Charlotte-Mecklenburg Planning, Design, & Development

SUBJECT: Administrative Approval for Petition No. 2017-052 Southminster, Inc

SOUTHMINSTER RETIREMENT COMMUNITY
CHARLOTTE, NC
REZONING PETITION # 2017-052

**SCHEMATIC
 SITE PLAN**

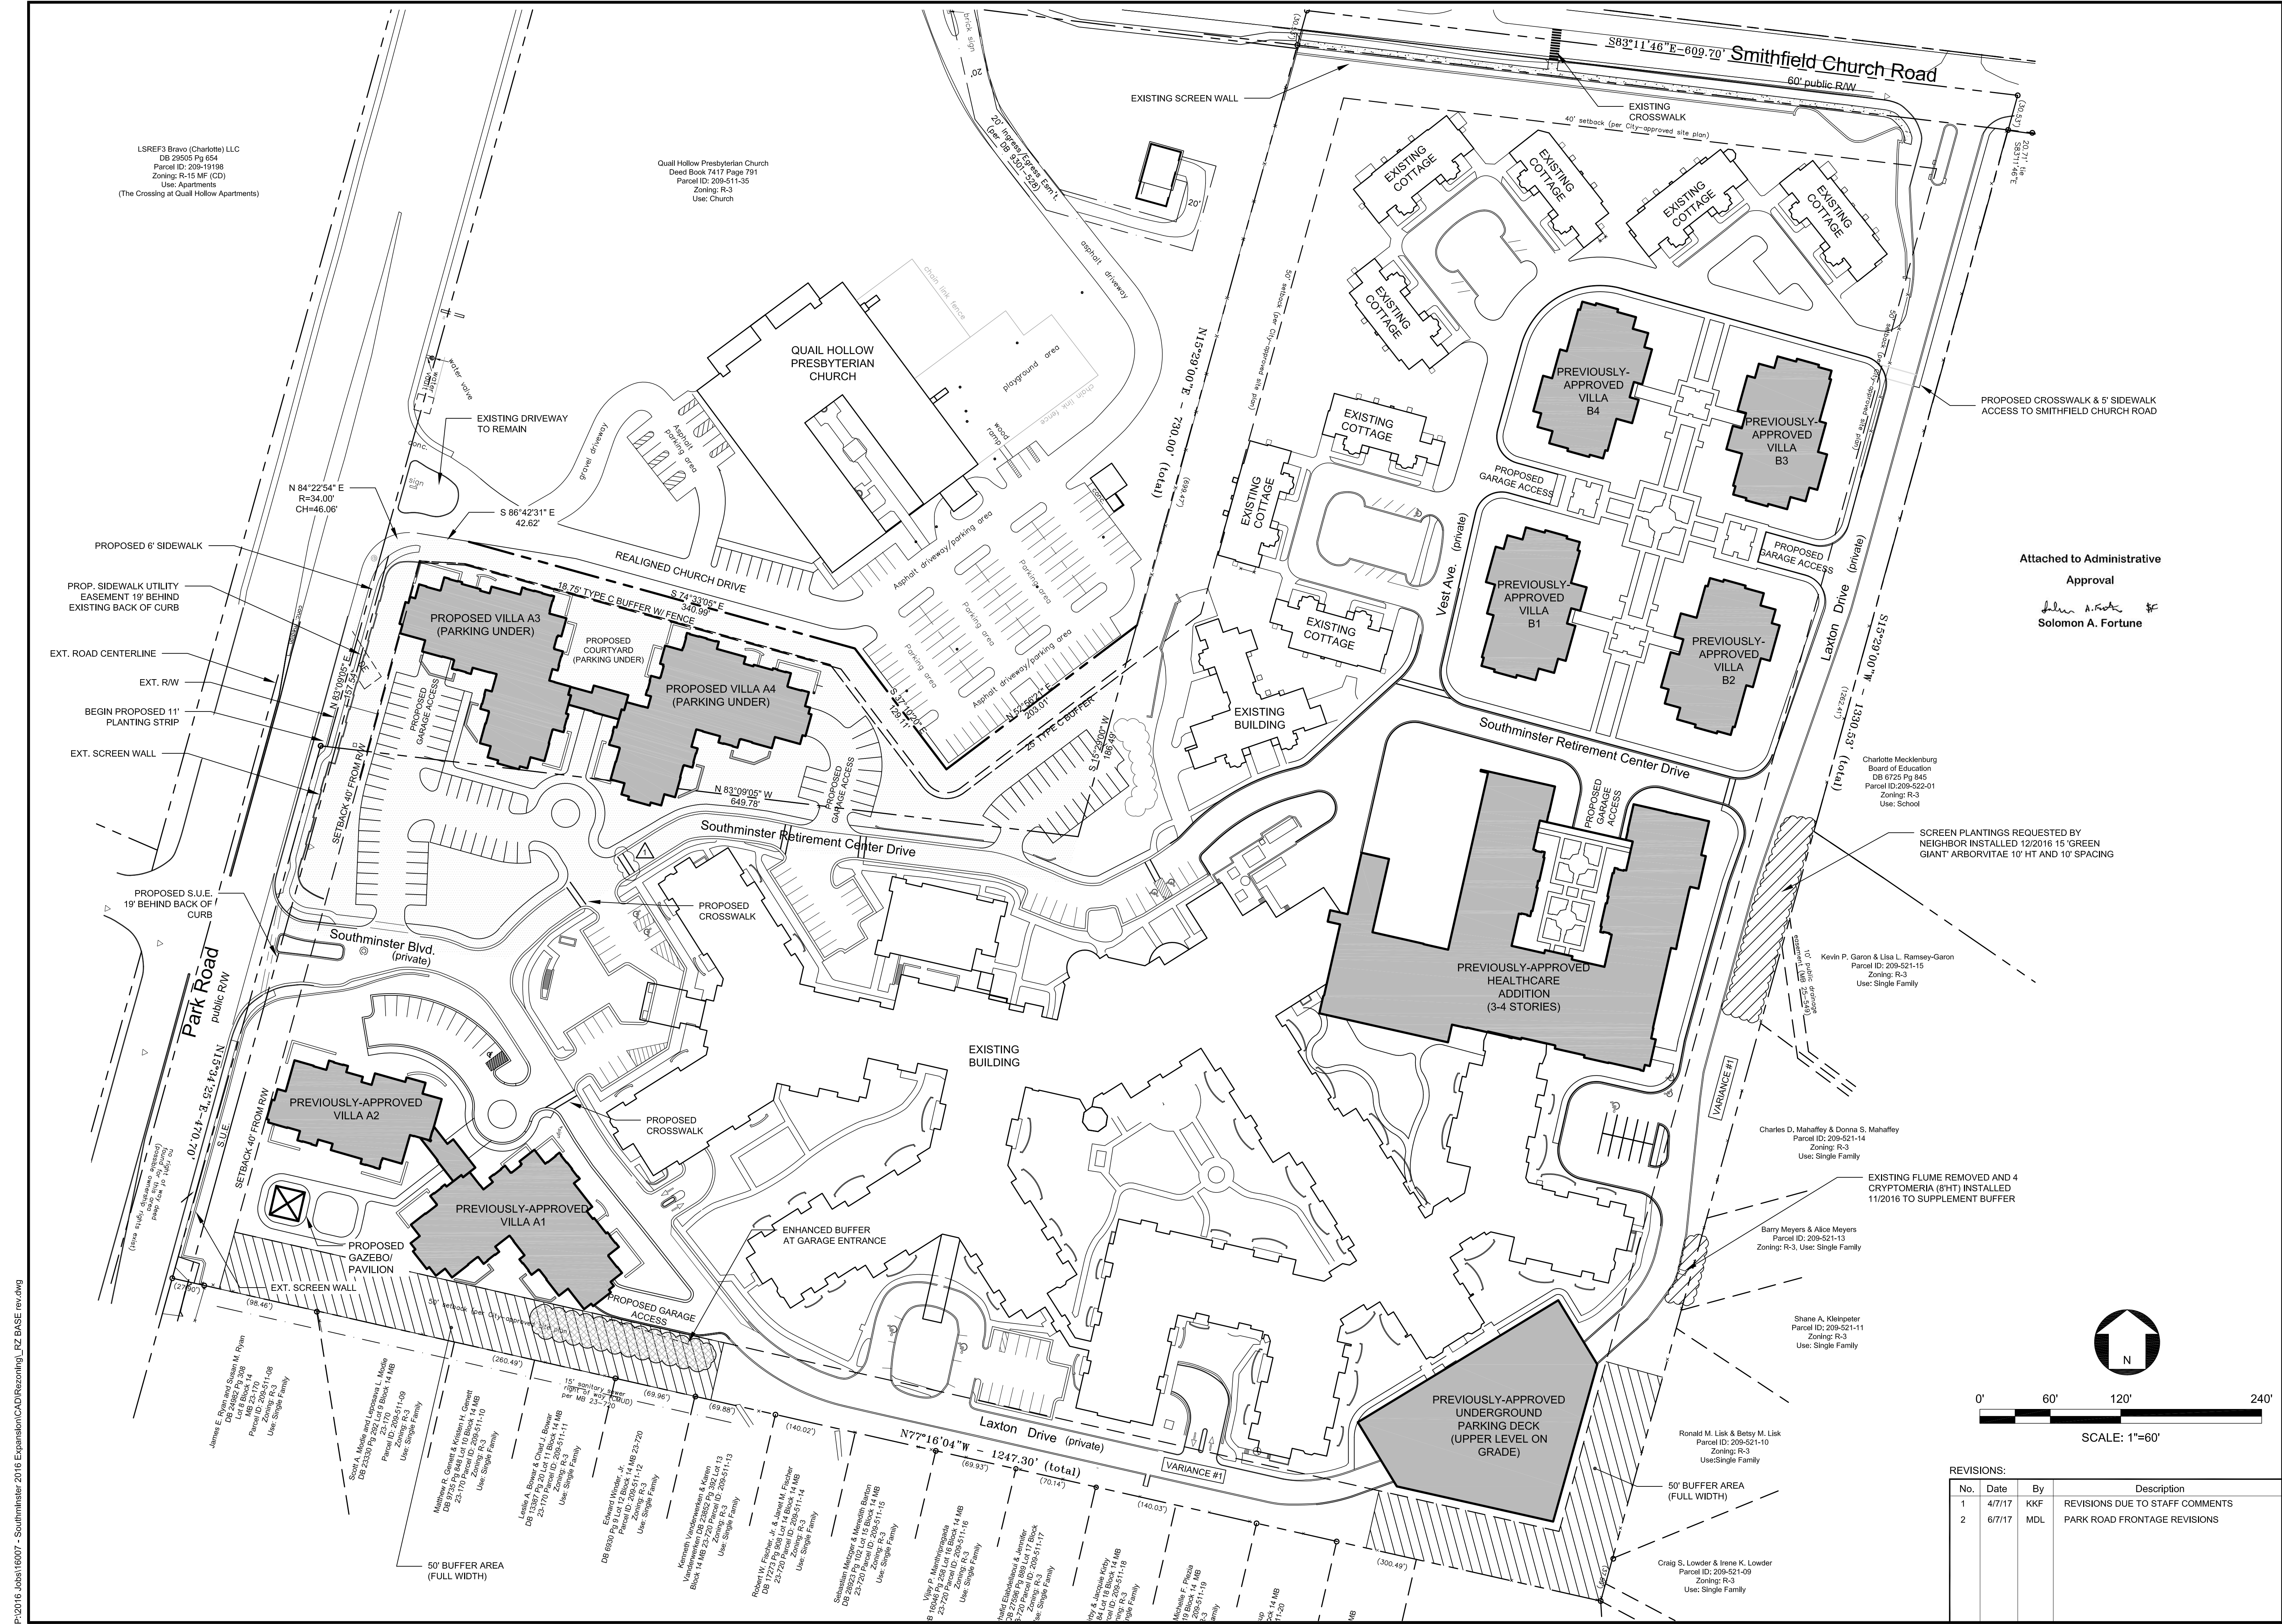
- To allow a modification to the required transportation improvements.
